Docket Item # 4 BAR CASE #2009-0003

BAR Meeting February 4, 2009

ISSUE: Alterations

LOCATION: 507 South Saint Asaph Street

Figure 1: Photographs of Existing

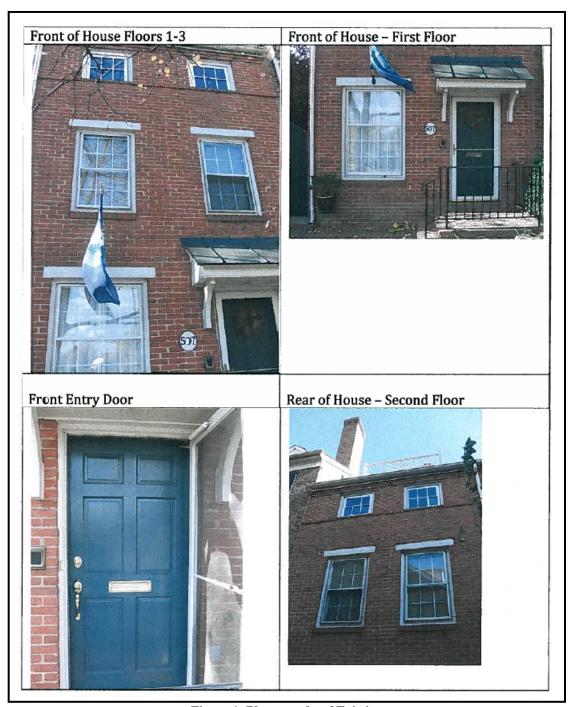
The applicant is requesting approval to replace a total of five windows; three on the front of the home facing South Saint Asaph Street and two on the rear. The existing windows are single-glazed, double-hung, six-over-six (second floor windows) and eight-over-twelve (first floor window) wood windows with exterior storms. The applicant is requesting approval of Marvin Ultimate Wood Double Hung double-glazed windows with 7/8" muntins. The proposed windows will be simulated divided light with an interior spacer and an identical light pattern to the window they are replacing.

The applicant is also requesting approval of a replacement front entry door. The existing front door is a traditional six paneled wood door which the applicant would like to replace with a Simpson, Red Oak, four paneled door with four double glazed lights across the top of the door.

As stated in The *Design Guidelines*, "Doors and their surrounds are as much a character defining feature of architectural styles as windows," additionally, "Exterior doors and storm doors constitute prominent visual details of the main façade of a building." Staff finds the proposed replacement door appropriate and in keeping with the historic integrity of the district.

IV. <u>STAFF RECOMMENDATION</u>: Staff recommends approval of the application as submitted.
